APPLICATION NO.	FILING DATE	FIRST NAMED INVENTOR	ATTORNEY DOCKET NO.	CONFIRMATION N
10/068,670	02/05/2002	Rudolf Ehwald	14305	8791
25763	7590	11/02/2004	EXAMINER	
DORSEY & WHITNEY LLP INTELLECTUAL PROPERTY DEPARTMENT 50 SOUTH SIXTH STREET MINNEAPOLIS, MN 55402-1498			MENDEZ, MANUEL A	
			ART UNIT	PAPER NUMBER
			3763

Office Action Summary	Application No. 10/068,670	Applicant(s) EHWALD ET AL.	
	Examiner Manuel Mendez	Art Unit 3763

DETAILED ACTION

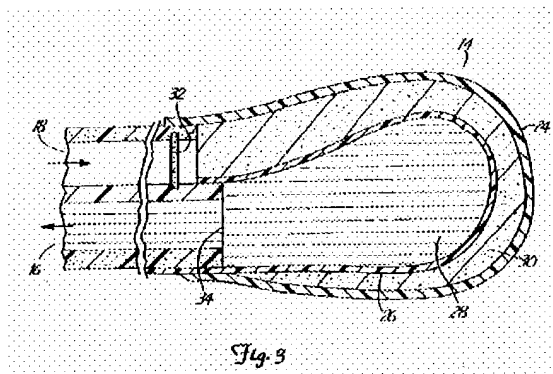
Claims 28, 46, and 61 are rejected under 35 U.S.C. 102(e) as being anticipated by Odland. The Odland Patent shows in figure 3 below, a probe comprising a proximal probe opening providing access to a supply line and a drainage line; a distal probe tip for introducing the probe into subcutaneous tissue, a supply line for introducing drip-feed solution into the probe, a drainage line; a dialysis section being formed between the supply line and the drainage line; the drip-feed solution flowing through the supply line in a flow direction, the flow direction being reversed in the area of the dialysis section and between the supply line and the drainage line.
